**Re: Christina Lake Thermal Project Phase H and Eastern Expansion
Project Update and Supplemental Information Request 2 Responses
AER Application No. 1758947
EPEA Application No. 019-48522**

The purpose of this document is to provide responses to the Round 2 SIR package and provide updated information regarding the Project (Project Update). This document is organized into two parts as follows:

PROJECT		cenovus ENERGY		CHRISTINA LAKE THERMAL PROJECT PHASE H AND EASTERN EXPANSION	
TITLE					
CLEARWATER B SOURCE WELLS TDS vs TIME					
PROJECT		3280-514		FILE No. 3280-CH-SIR-14.CDR	
DESIGN	AH	March 2014		SCALE	AS SHOWN
CADD	ER	March 2014		REV.	0
CHECK	SP	---		FIGURE: 3-1	
REVIEW	WW	---

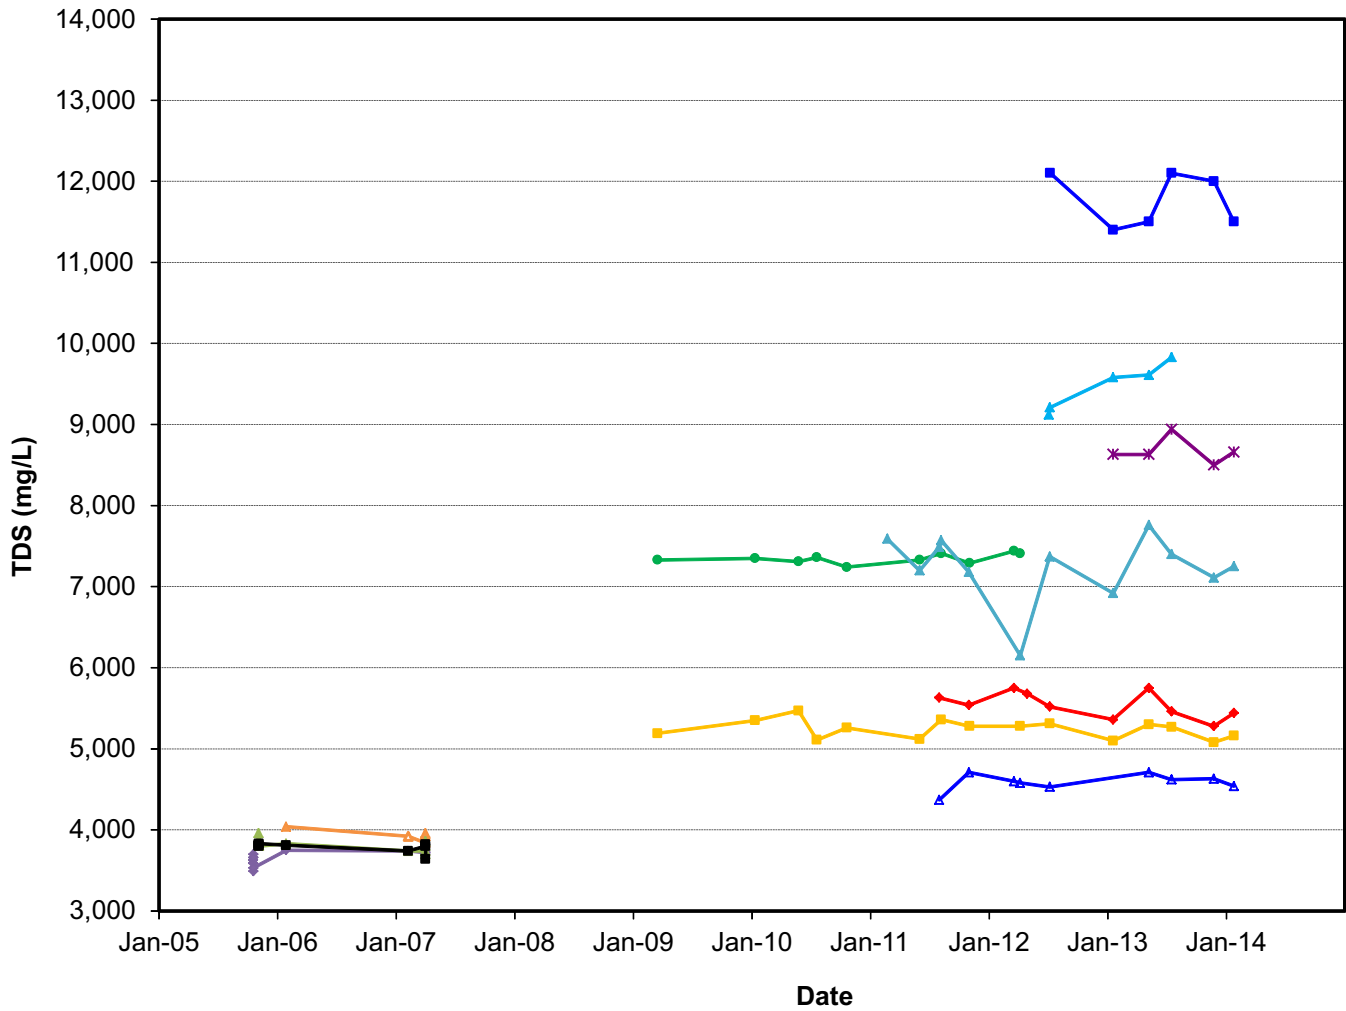
3. **SIR 1, Response 19: Table 19-1 and Figure 19-1, Pages 41 to 44. The subject table and figure did not include historical chemistries from Clearwater B water source wells F2/11-09-076-06W4M, F2/9-16-076-06W4M, or BW-A 100/3-17-076-06W4M, which were discussed in the response. Update Table 19-1 and Figure 19-1 to include the above three water source wells. If any additional Clearwater B source wells were missed, add them to the table and figure as well.**

The AER Round 1 SIR 19, Figure 19-1 and Table 19-1 have been updated and are included as [Figure 3-1](#) and [Table 3-1](#). Well 1F2/9-16-076-06W4M was not the correct well name, rather it is 1F1/10-16-076-06. The data from this well is included in [Figure 3-1](#) and [Table 3-1](#).

cenovus ENERGY		CHRISTINA LAKE THERMAL PROJECT PHASE H AND EASTERN EXPANSION	
ENVIRONMENTAL CONSTRAINTS MAP			
	PROJECT	14-1346-0011	FILE No.
	DESIGN	JG 06 Dec. 2014	SCALE AS SHOWN
	GIS	GU 15 Jan. 2015	REV. 0
	CHECK	RL 15 Jan. 2015	
	REVIEW	SNS 15 Jan. 2015	
			FIGURE: 11-1

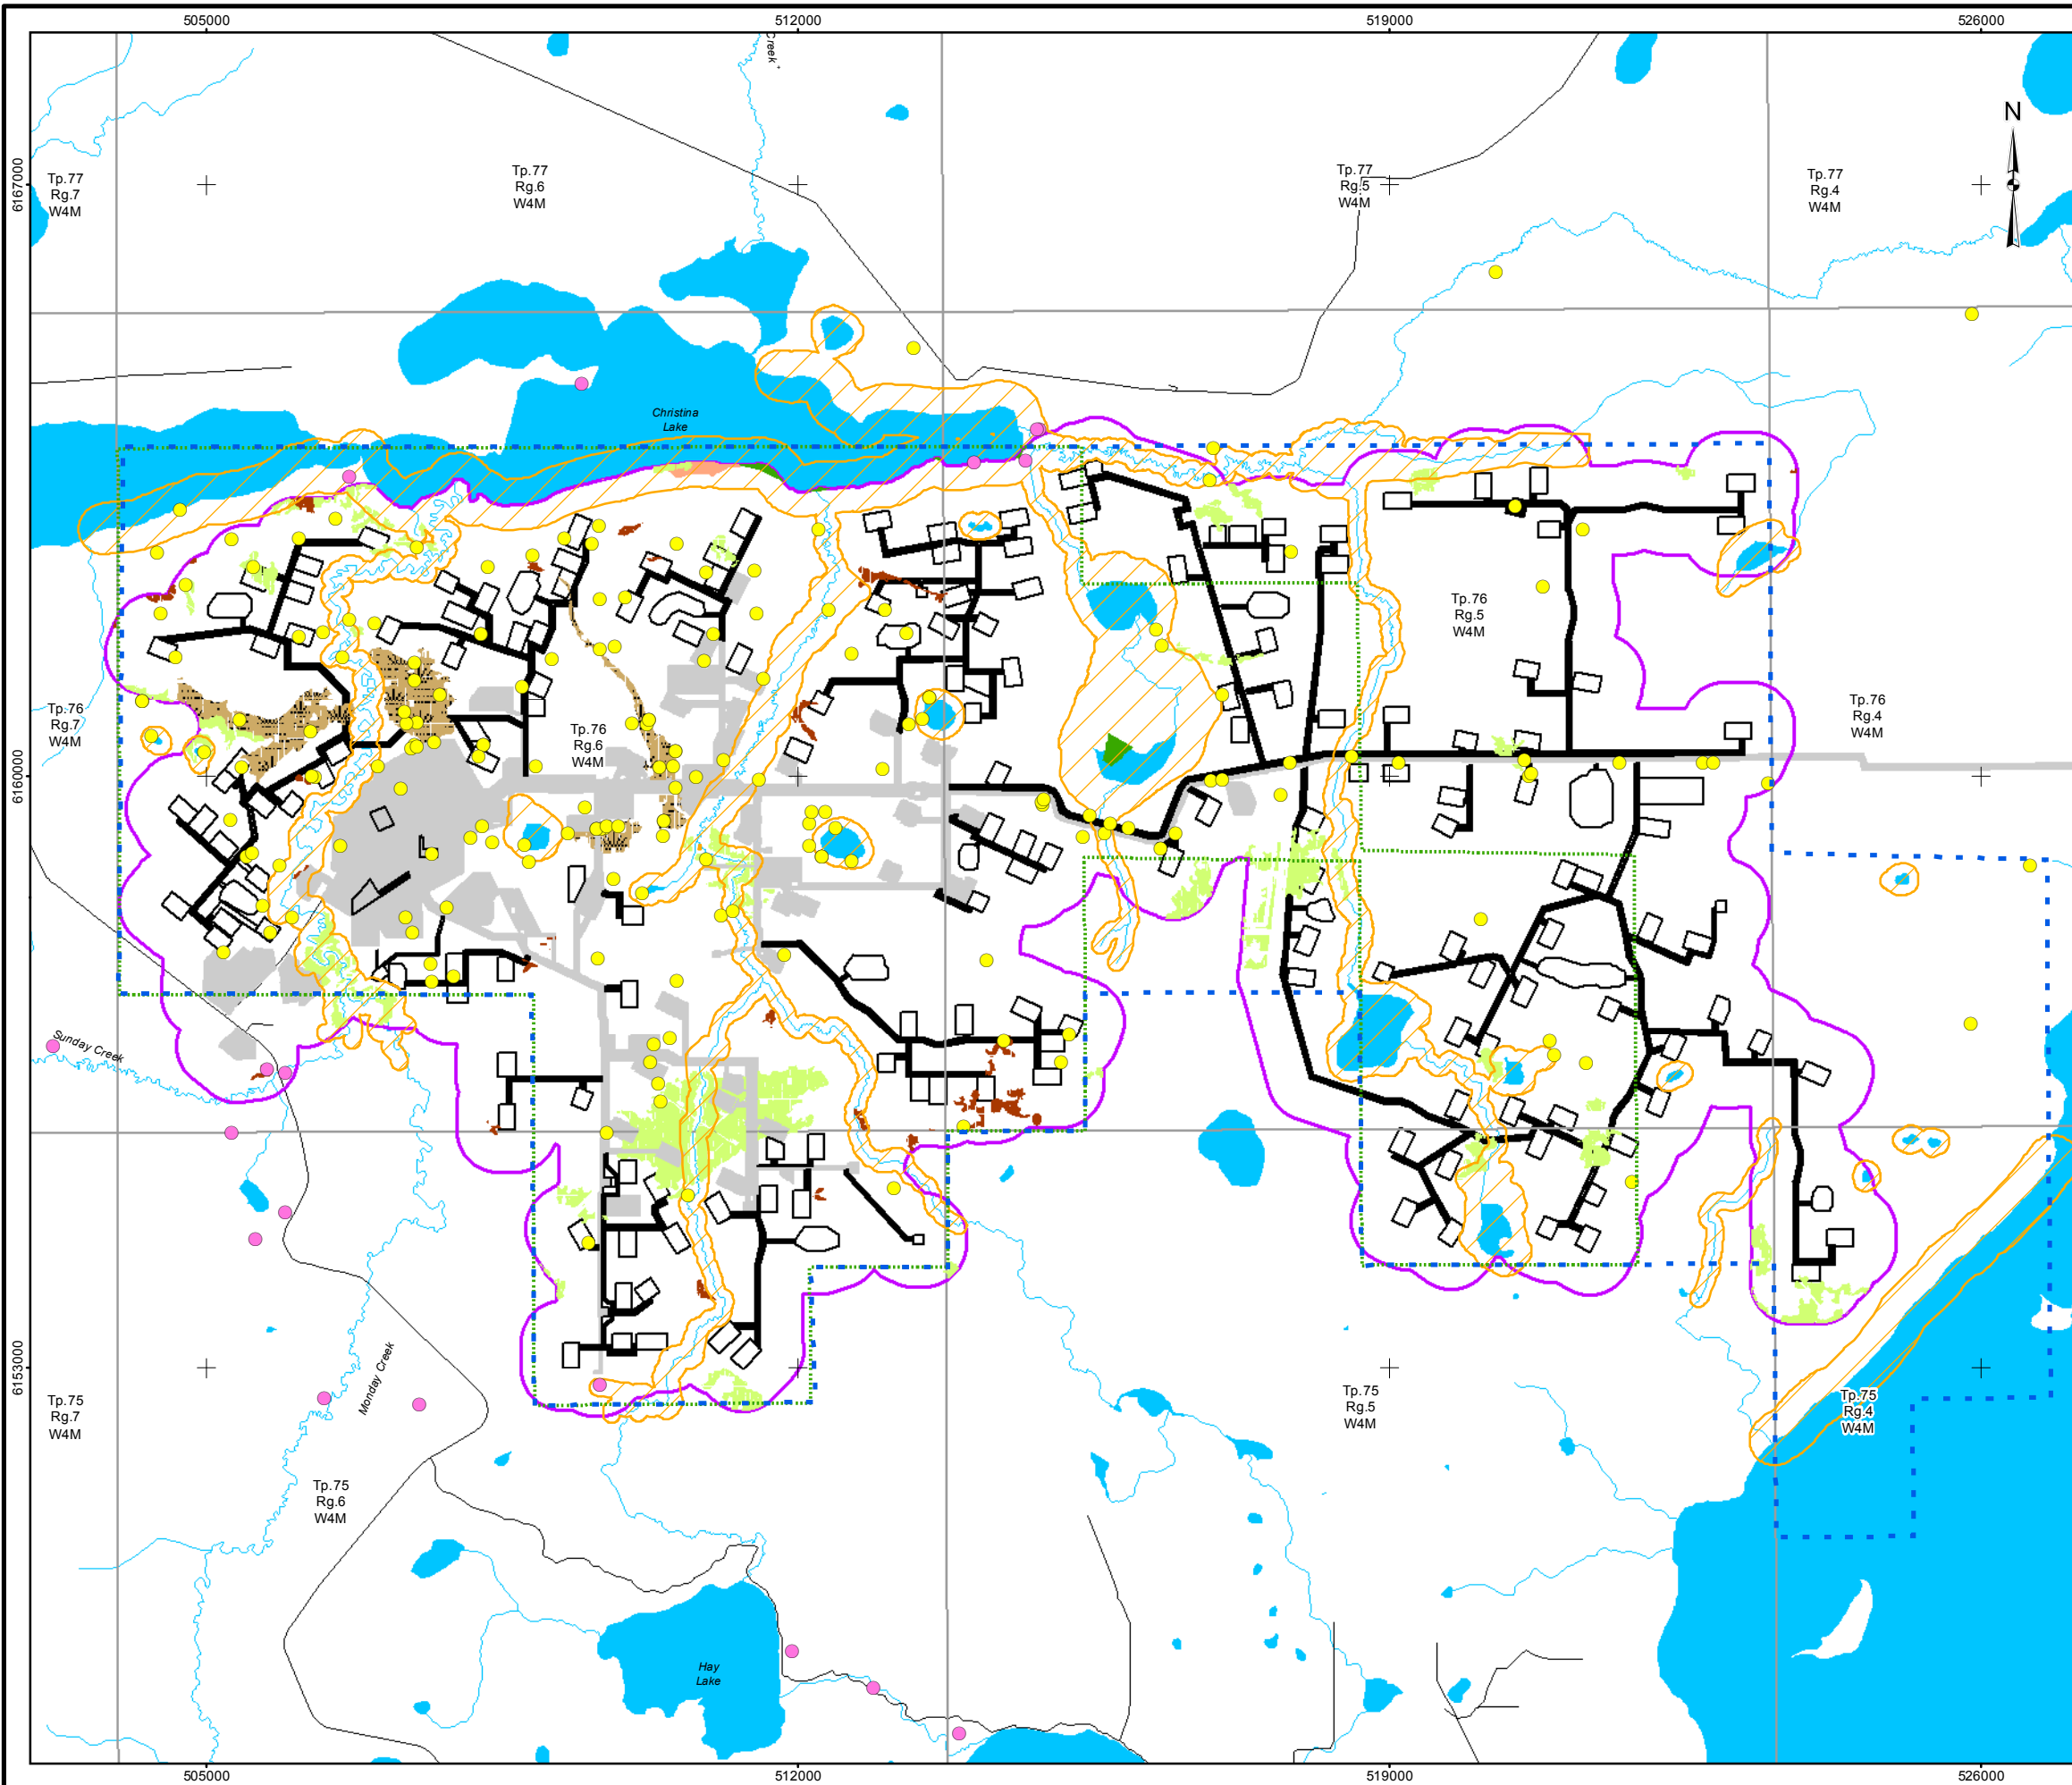
- a. Clarify the setback Cenovus intends to maintain from Winefred Lake.**
- b. Provide a surface constraints map identifying all environmental constraints considered as part of the disturbance footprint selection process. The figure should illustrate sensitive areas located in the area of the proposed project (e.g., anthropogenic features, patterned fen, rare plants, old growth forest, a1 ecosite phases, non-burned areas, etc.), the setbacks utilized from water bodies, the proposed project and development area boundaries, and the full project footprint. On Page 859 of Volume 5, it is stated that a potential movement corridor for woodland caribou was identified in the CLTP area. Include identification of this potential corridor on the constraints map.**

- c. Reference the above-identified features and discuss how footprint locations were selected in support of minimizing environmental impacts. The discussion must include specific references to features such as patterned fen, undisturbed caribou habitat and the potential caribou movement corridor. Provide site-specific examples for the development area that include identification of the trade-offs made.**

- a. The setback Cenovus intends to maintain from the high water mark of Winefred Lake is 400 m.
- b. See [Figure 11-1](#) for the requested environmental constraints map. The potential north-south movement corridor for woodland caribou discussed in Volume 5, Appendix 5-III, Section 6.3 is not shown in [Figure 11-1](#) because it does not have defined boundaries. As stated in the EIA, the potential north-south corridor appears to exist between caribou wintering areas within peatland complexes north of Christina Lake and spring calving/summer habitats south of Christina Lake (Kansas 2005, pers. comm.). Caribou appear to move south to calving areas by either crossing Christina Lake or moving between Christina Lake and Winefred Lake (Kansas 2005, pers. comm.). However, it is difficult to confirm woodland caribou movement patterns and it is possible that the caribou in the CLTP area move south in winter, instead of north (Golder 2012).

Due to the trade-off of maximizing recovery of the resource, it was not possible to avoid disturbance to all other sensitive environmental features, such as, rare plants, old growth forest, patterned fens and lichen jackpine ([Figure 11-1](#)). To reduce surface disturbance, the development footprint was minimized to the extent possible. For example, the number of production wells per well pad was increased, the use of existing rights-of-way and disturbed areas for access was maximized, and wildlife crossing opportunities along Project infrastructure were incorporated to minimize barriers to woodland caribou movement through the area. As a result, less than 10% of rare plant occurrences and old growth forest and 1% or less of patterned fens, caribou habitat and lichen jackpine present in the LSA in the Baseline Case will be affected by the Project footprint.

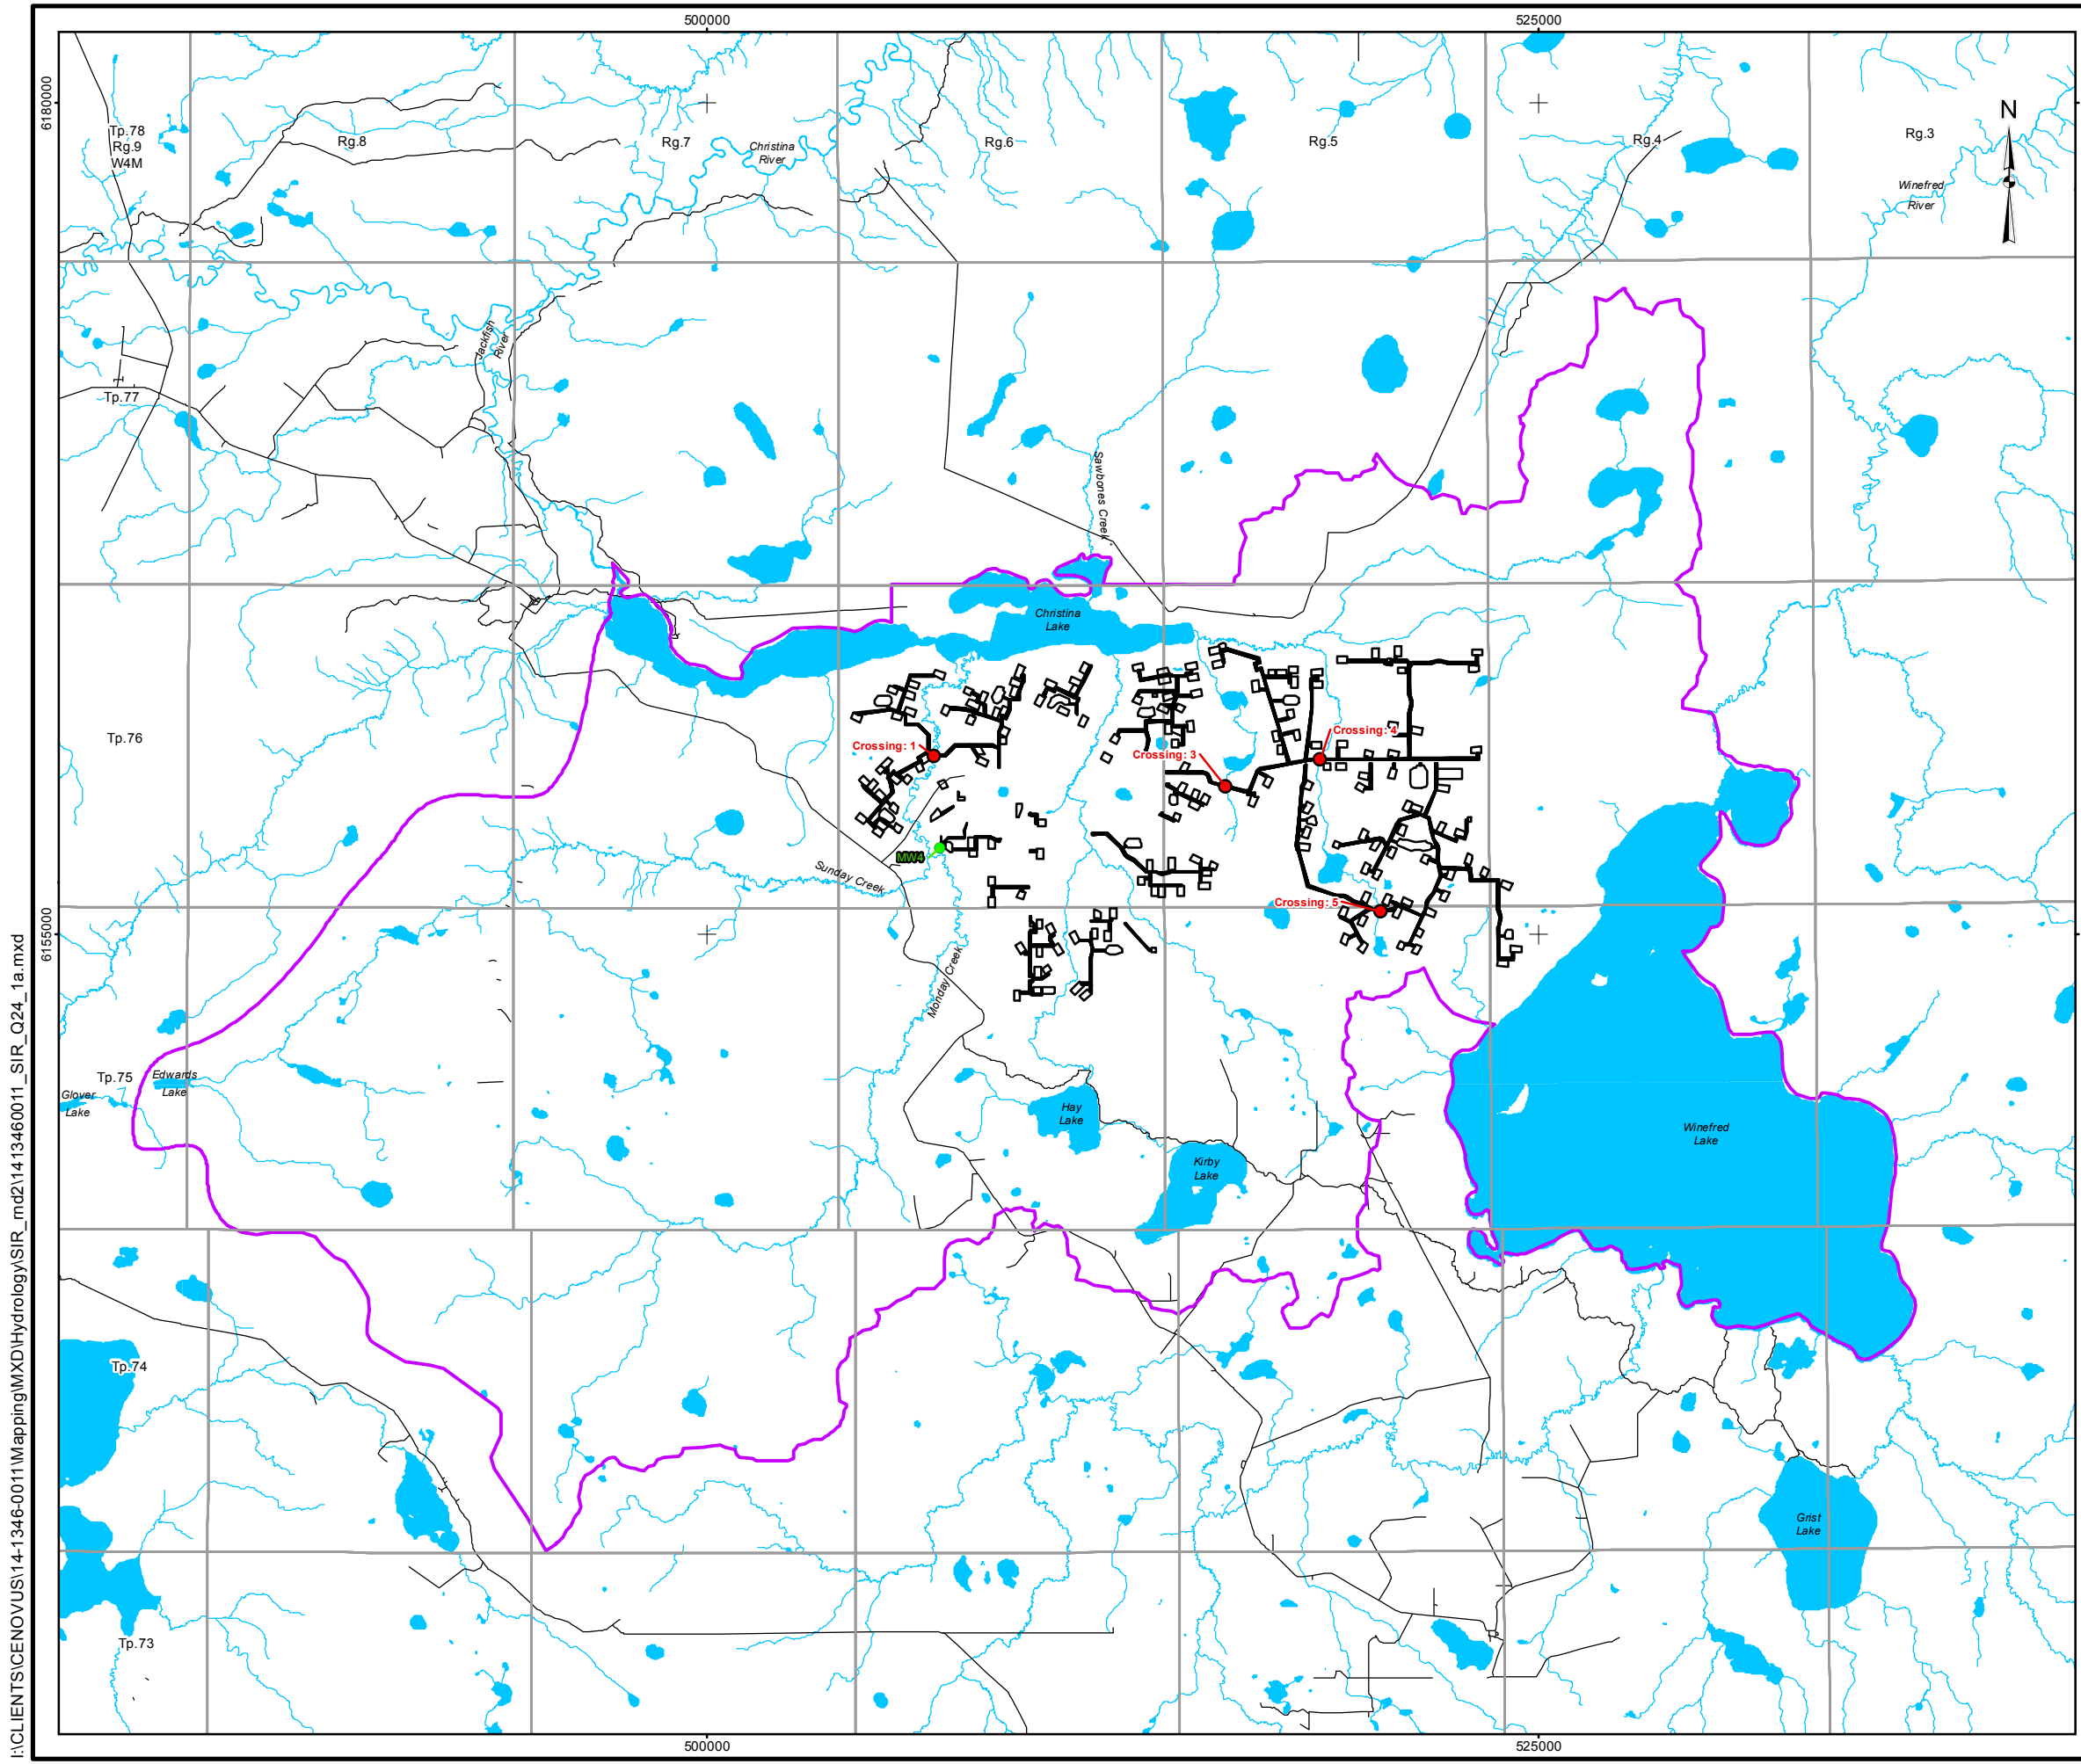
- b. **Contrast the identified locations with potential alternate locations outside of the 100m setback. Include a discussion of the surface and subsurface constraints that were considered.**

- a. Cenovus has reviewed the footprint relative to the waterbody and watercourse setback requirements and has prepared an alternate proposed footprint as shown in [Figure 24-1A](#) (overview) and [Figures 24-1B to 24-1F](#) (detailed views). Well pads previously located within the 100 m buffer have been relocated outside of the buffer. The updated distances from the watercourse or waterbody are provided in ESRD Round 2 SIR 26, [Table 26-1](#).

- b. The proposed alternative well pad locations are provided in [Figures 24-1A to 24-1F](#). Subsurface and surface constraints considered are discussed in the response to ESRD Round 2 [SIRs 7 and 11](#).
